TECHNICAL SERVICE BULLETIN

Bulletin Number: T-16-01
Model Year(s): 2016

SUBJECT: 2016 Slingshot SL and LE models – Backup Camera Replacement

BACKUP CAMERA REPLACEMENT

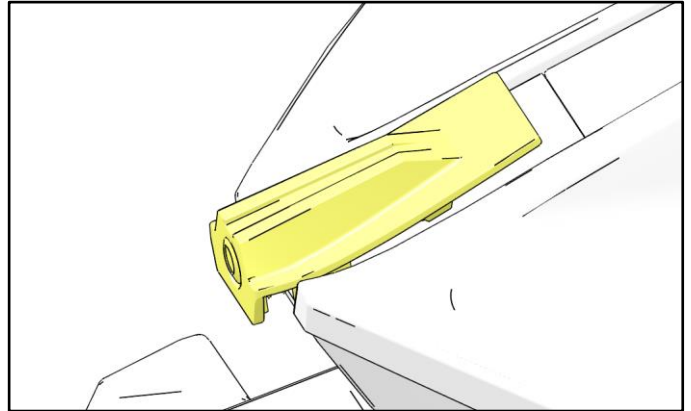
1. Carefully lift up on the backup camera mount to remove from the vehicle.

2. Gently pull on backup camera wire until the connector becomes visible. Disconnect the backup camera from the harness.

3. Press the camera out of the mount to remove.

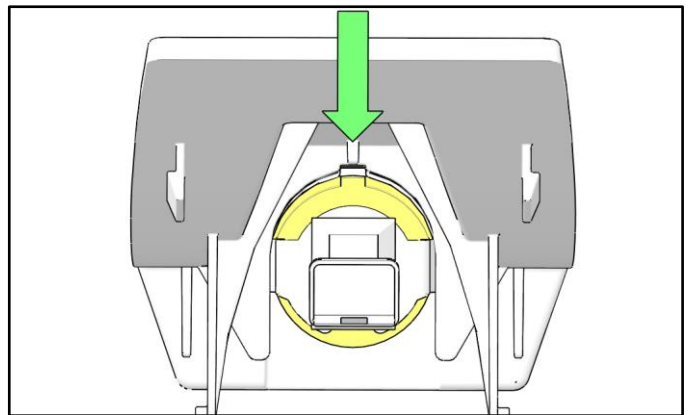
4. Connect the new camera to the harness.

5. Align the tab in the backup camera with the mount tab.

6. Secure the camera into the mount.

7. Install camera and mount to vehicle engaging retention tabs.

8. Test vehicle to verify normal operation of the radio and backup camera.
